**NEW BUILDING FACILITY:
CBC OFFICE BUILDING**

1
P-1
1st FLOOR PLUMBING PLAN
SCALE: 3/16" = 1'-0"

REV #	DATE	BY	CHECKED	DESCRIPTION
1	3/3/09	TGW		REVISED TO SUIT NEW FLOOR PLAN, RELOCATED FLOOR DRAIN, AND ADDED HUB DRAIN AT THE REQUEST OF THE GENERAL CONTRACTOR (A. KNIGHT). REFER TO EMAIL FROM ARCHITECT (D. RIPPERTON) DATED 2-20-09.

2nd FLOOR
PLUMBING PLAN
SCALE: 3/16" = 1'-0"

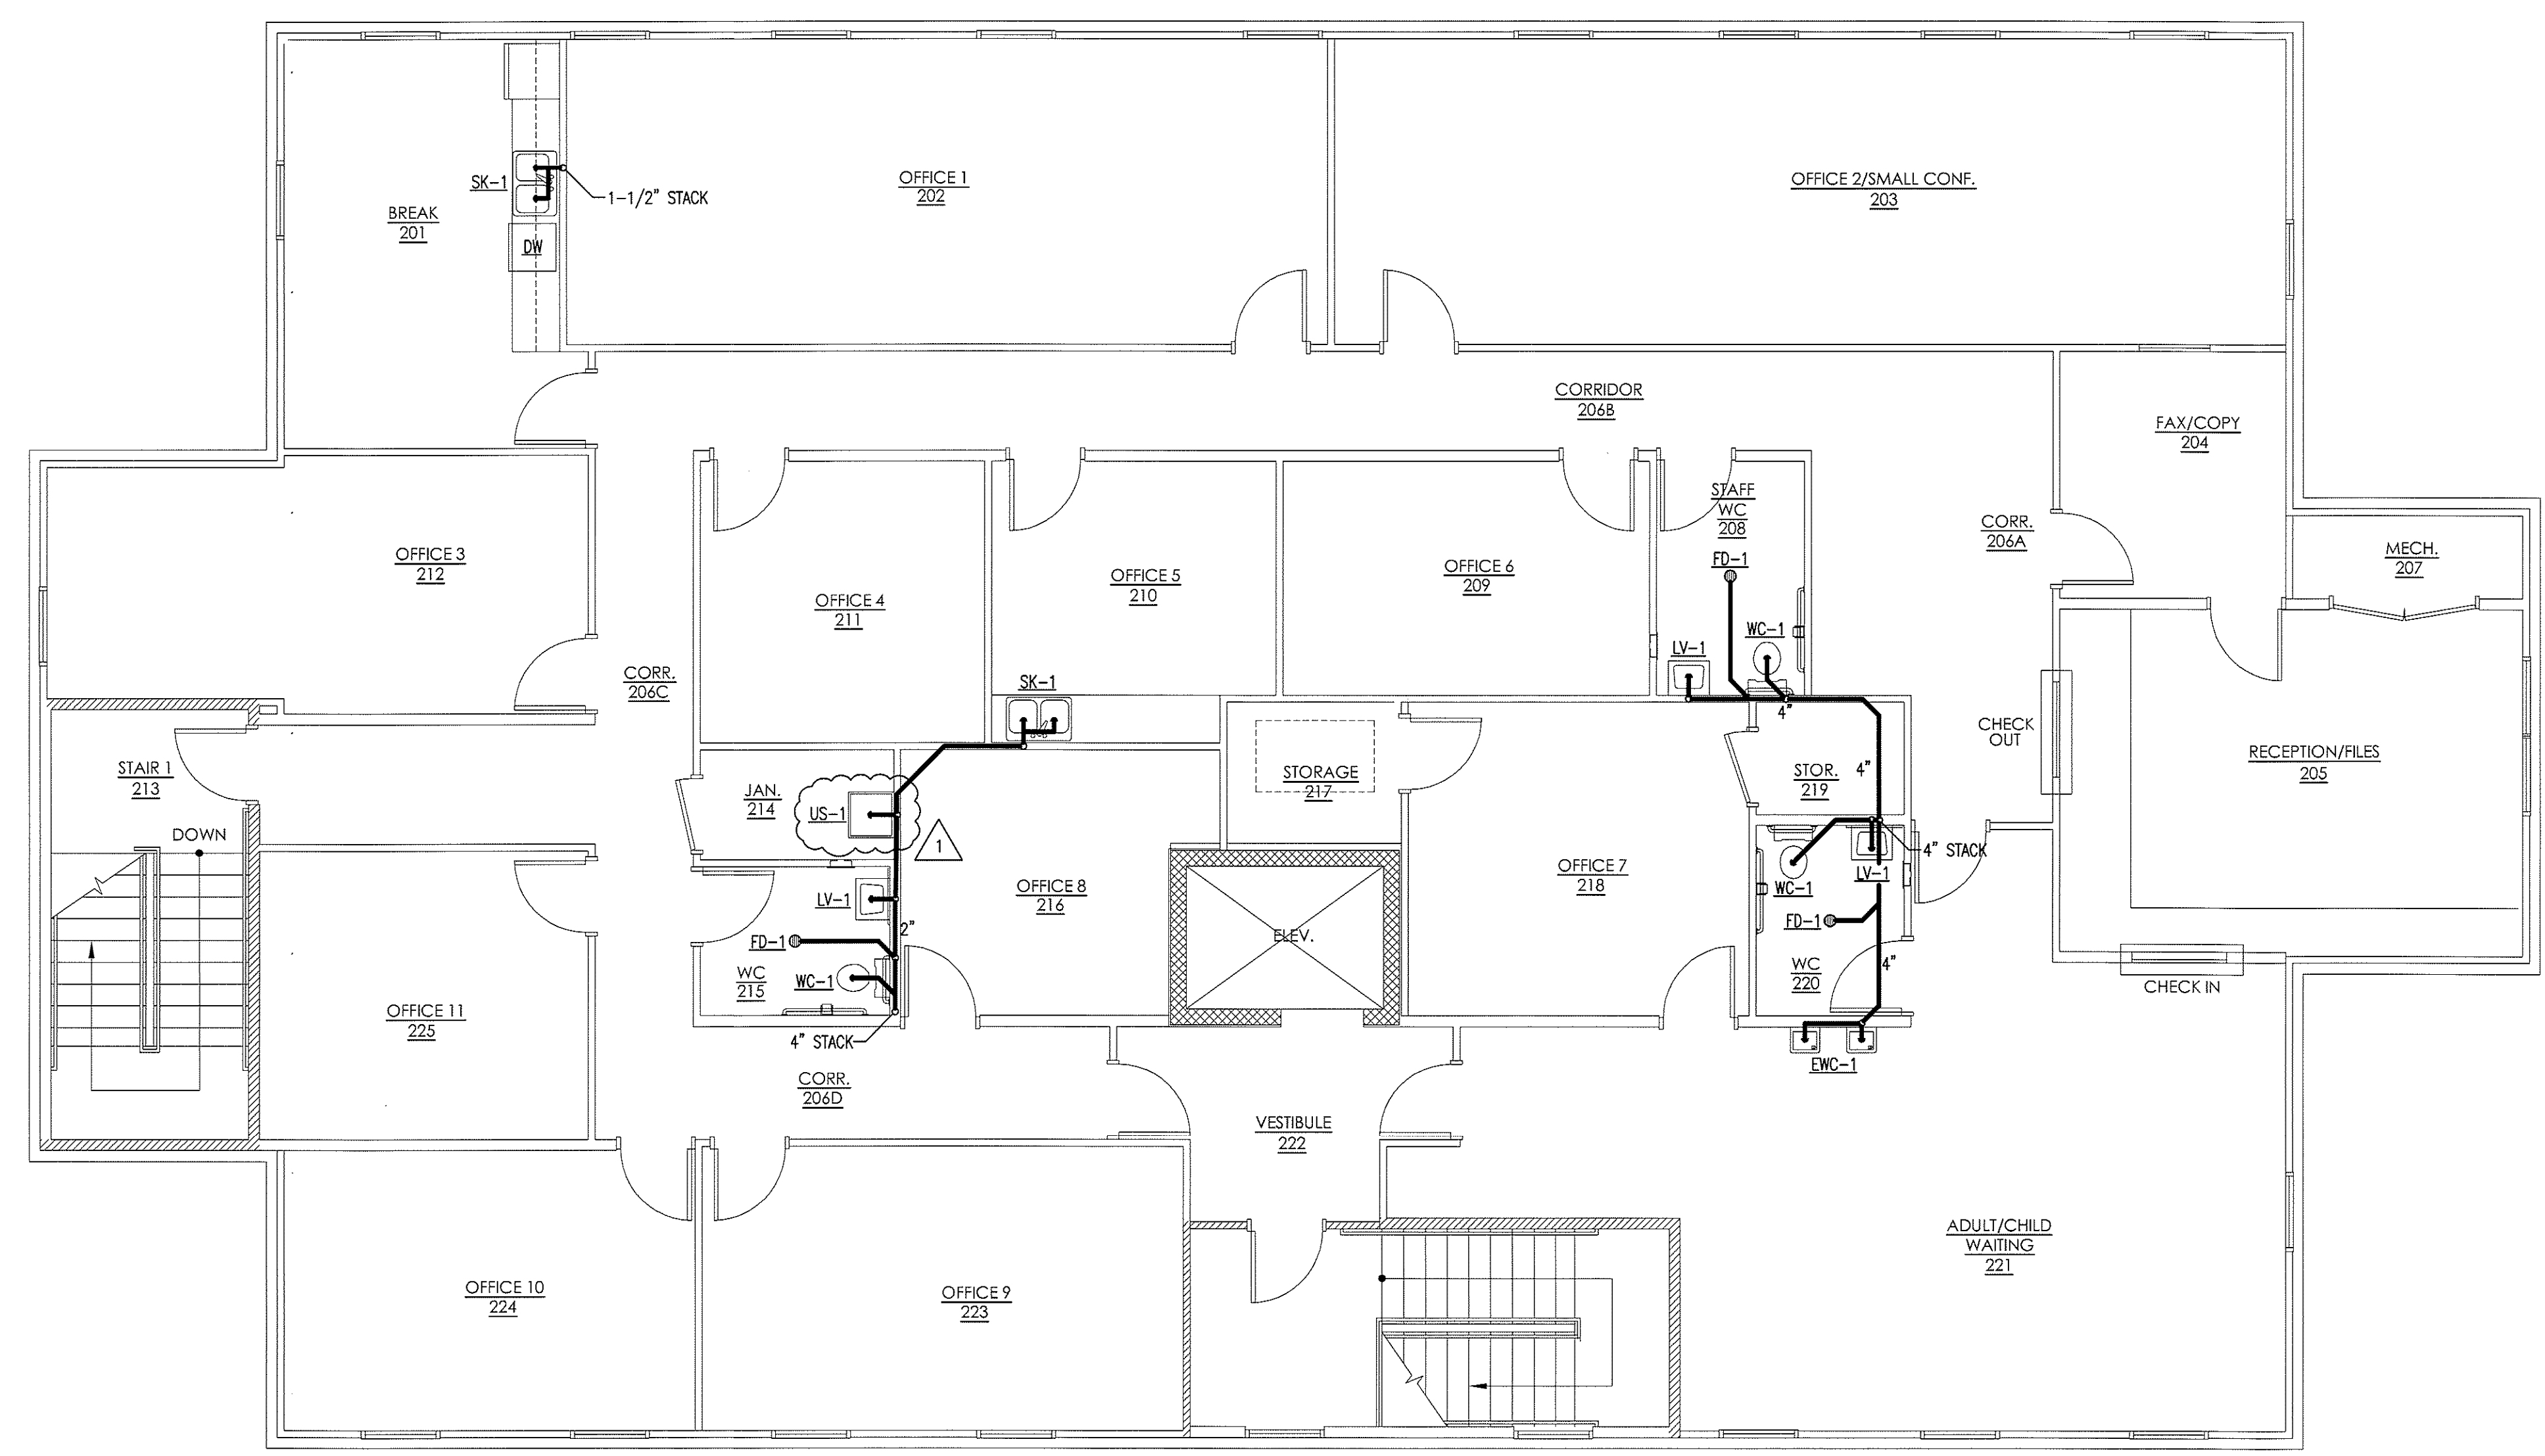
REV #	DATE	BY	CHECKED	DESCRIPTION
1	3/3/09	TGW	JNK	REVISED TO SUIT NEW FLOOR PLAN AND ADDED UTILITY SINK AT THE REQUEST OF THE GENERAL CONTRACTOR (A. KNIGHT). REFER TO EMAIL FROM ARCHITECT (D. RIPPERTON) DATED 2-20-09.

1st FLOOR
WATER PIPING PLAN
SCALE: 3/16" = 1'-0"

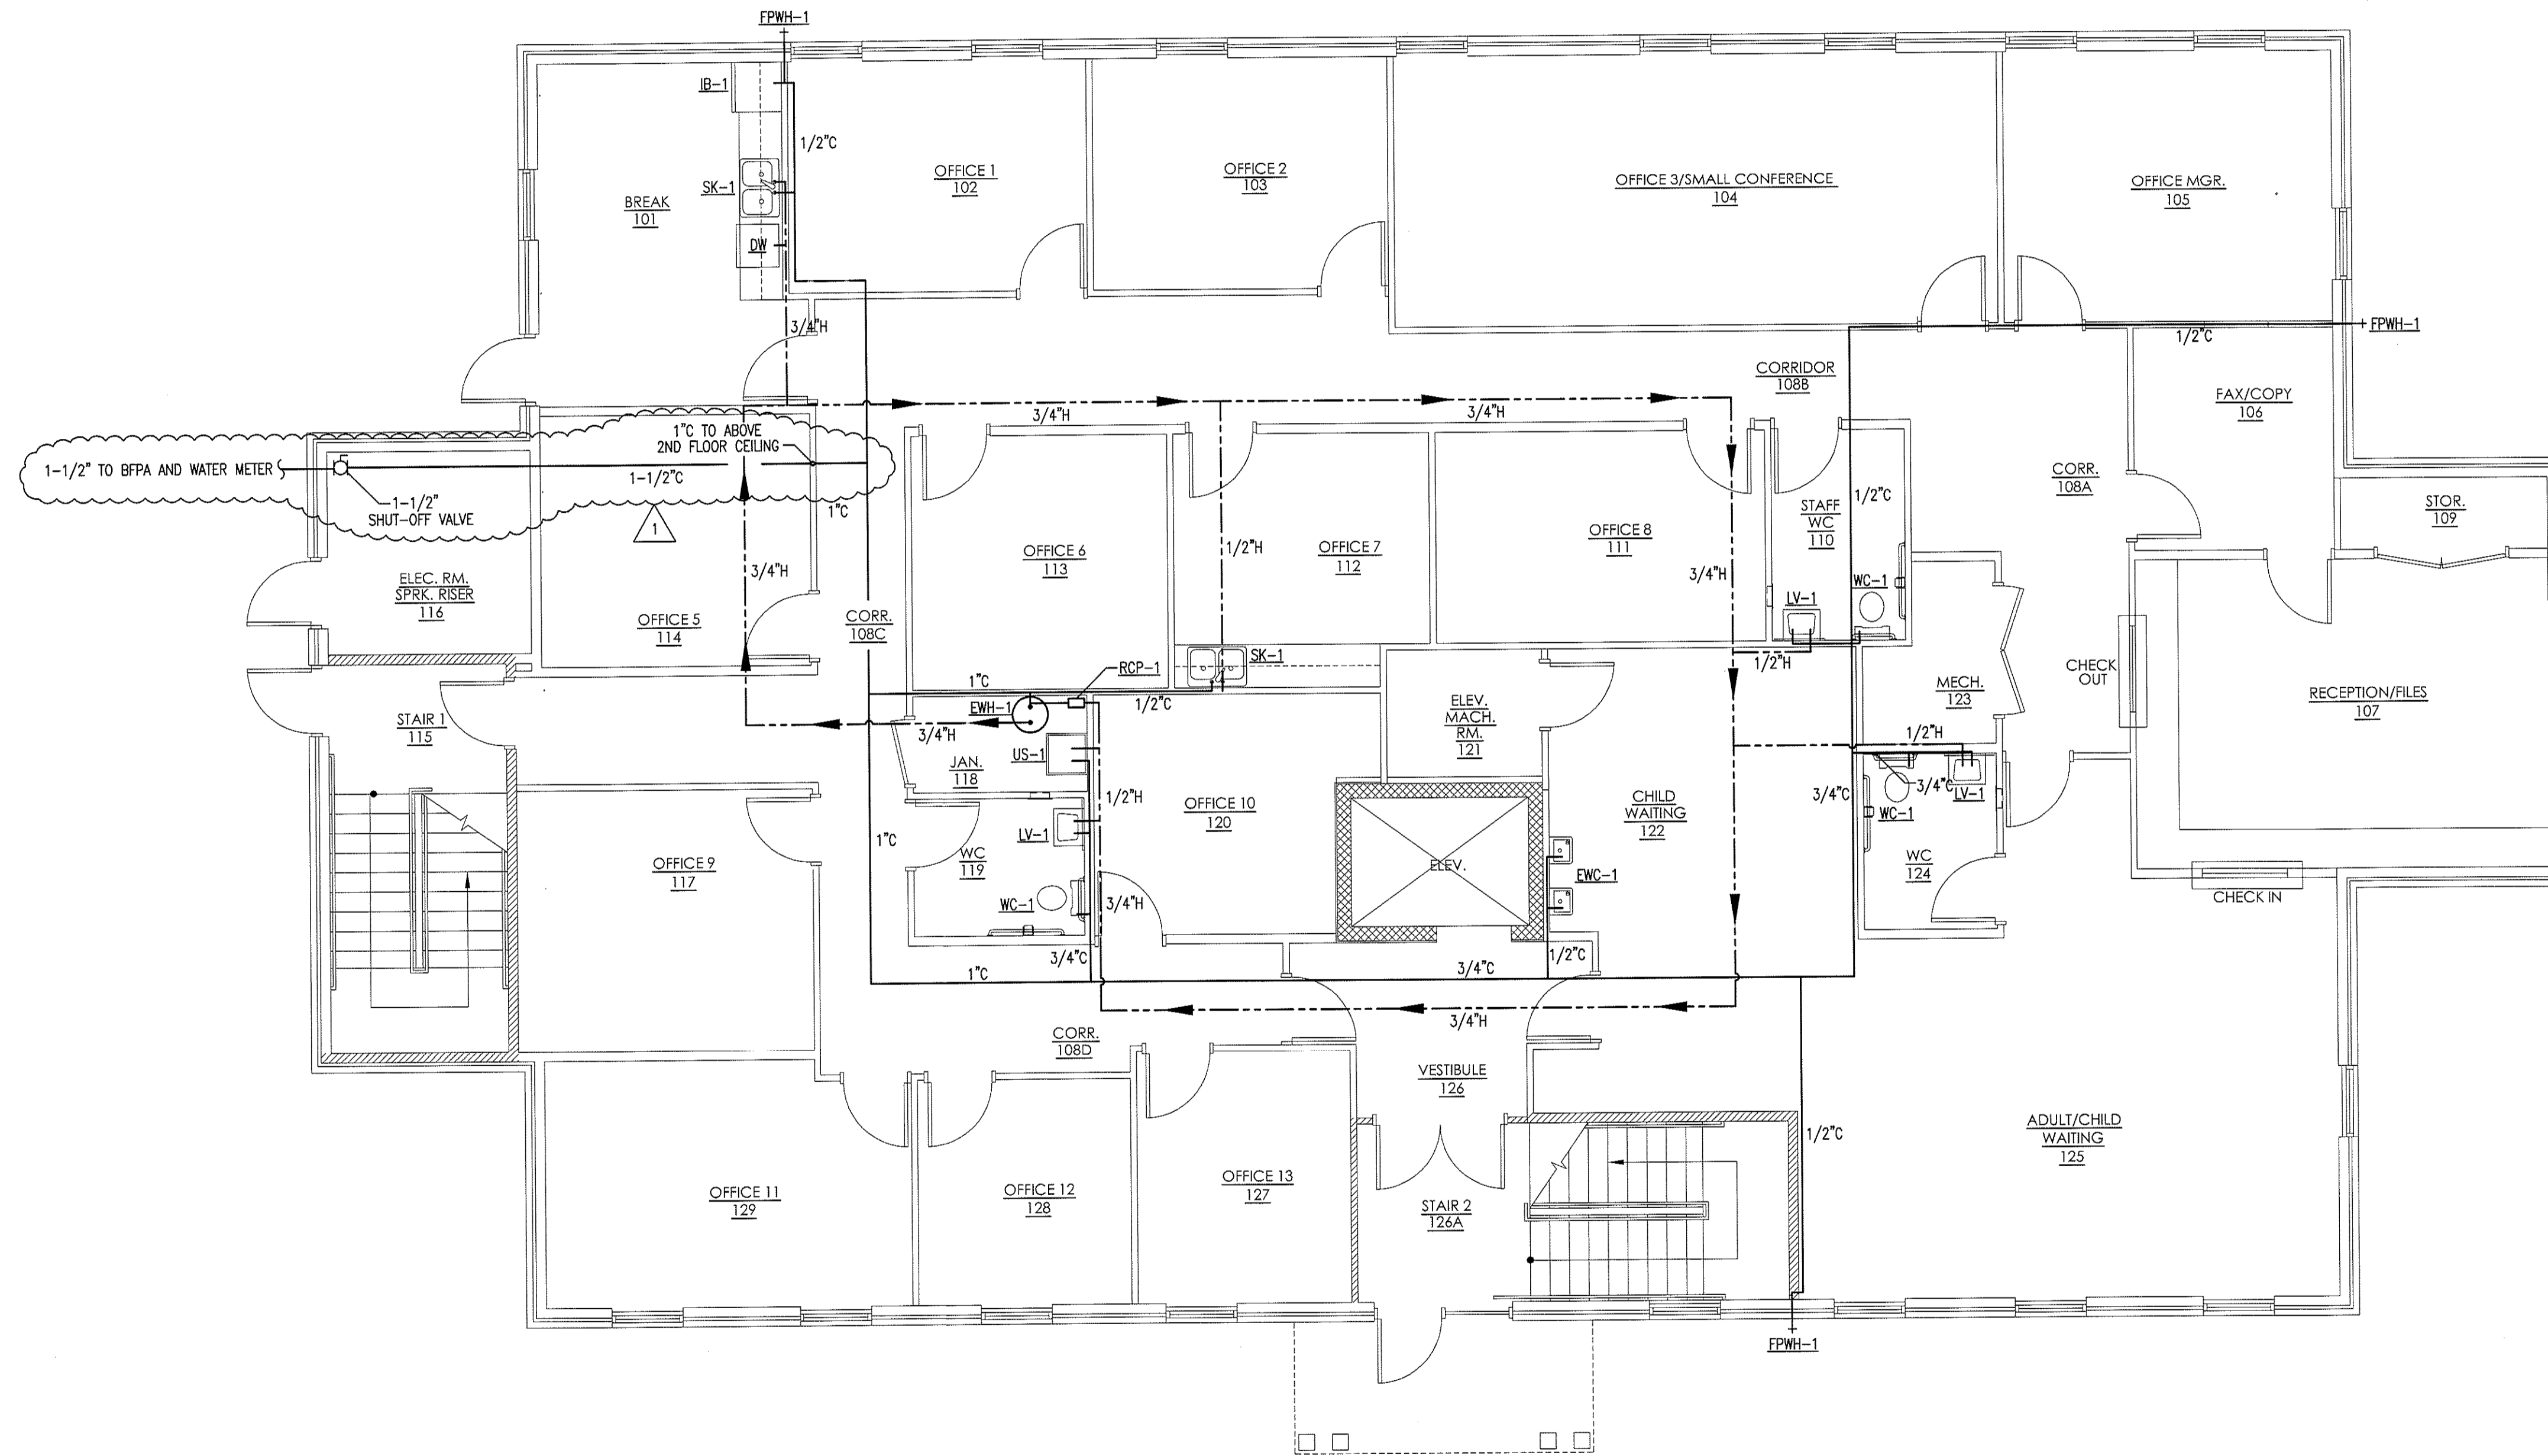
REV #	DATE	BY	CHECKED	DESCRIPTION
1	3/3/09	TGW	JNK	REVISED TO SUIT NEW FLOOR PLAN AND RELOCATED WATER ENTRY LOCATION AT THE REQUEST OF THE GENERAL CONTRACTOR (A. KNIGHT). REFER TO EMAIL FROM ARCHITECT (D. RIPPERTON) DATED 2-20-09.

2nd FLOOR
WATER PIPING PLAN
P-4
SCALE: 3/16" = 1'-0"

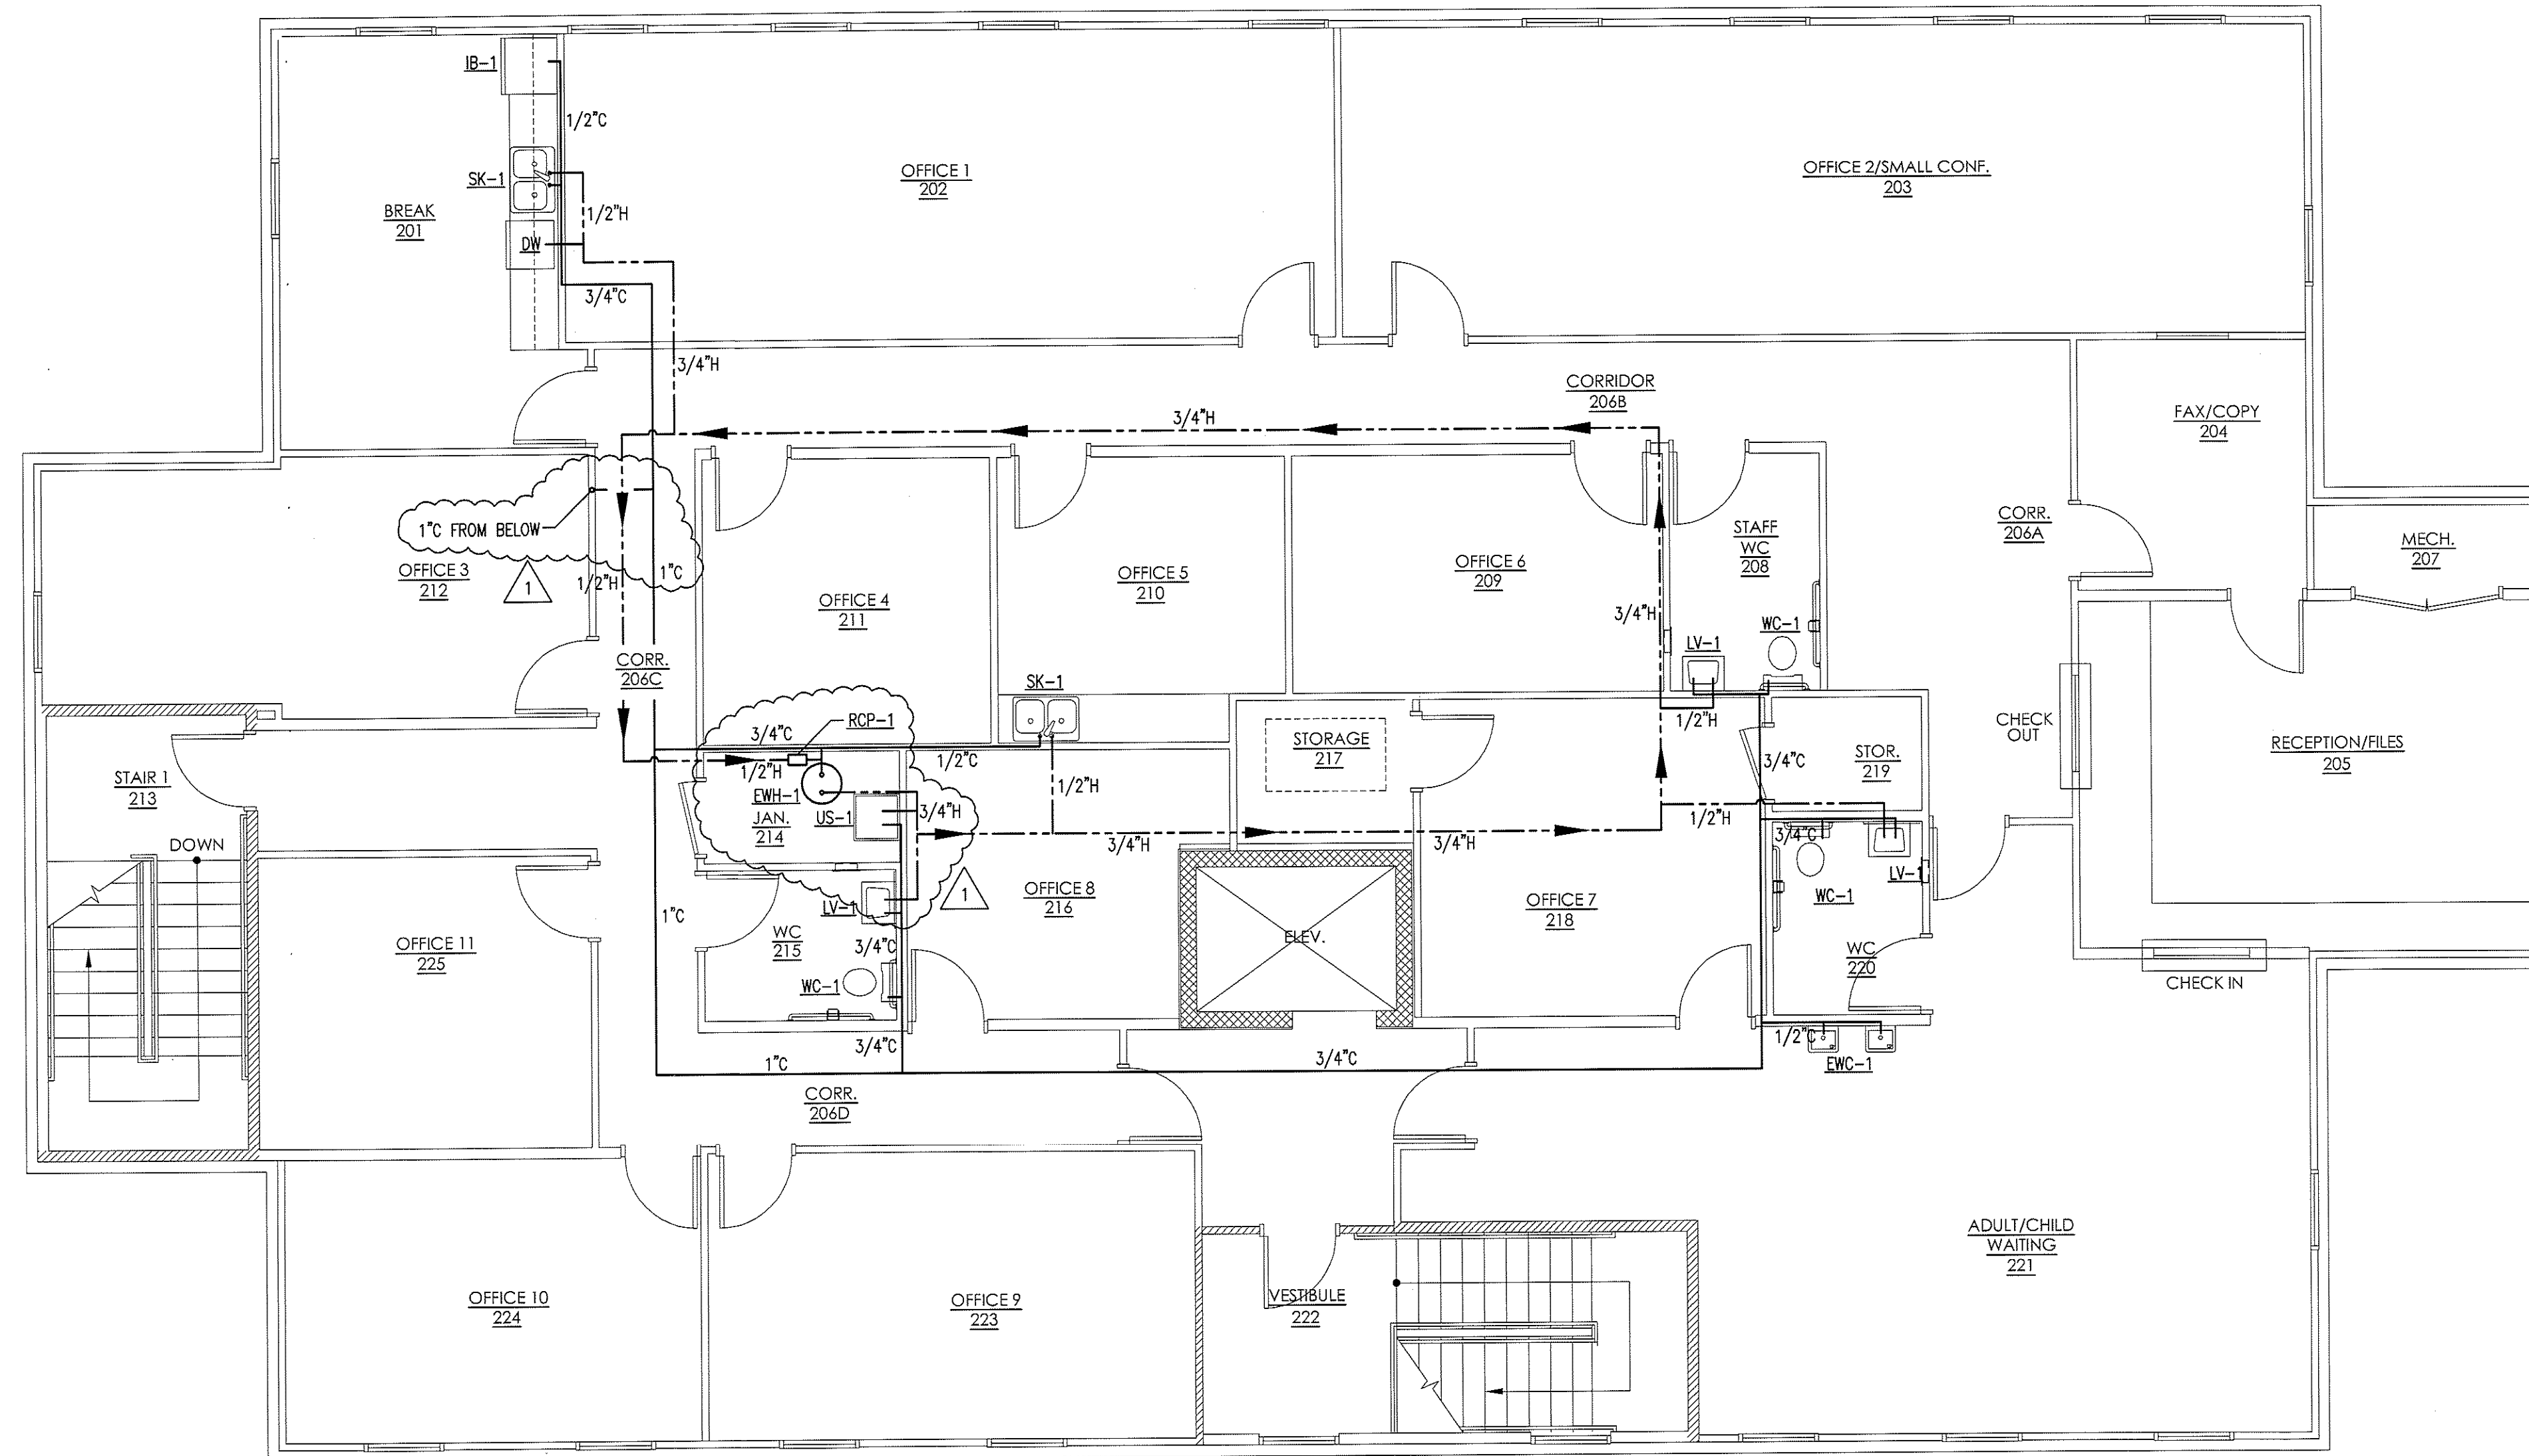
REV #	DATE	BY	CHECKED	DESCRIPTION
1	3/3/09	TGW	[Signature]	REVISED TO SUIT NEW FLOOR PLAN, RELOCATED WATER ENTRY LOCATION, AND ADDED UTILITY SINK AT THE REQUEST OF THE GENERAL CONTRACTOR (A. KNIGHT). REFER TO EMAIL FROM ARCHITECT (D. RIPPERTON) DATED 2-20-09.
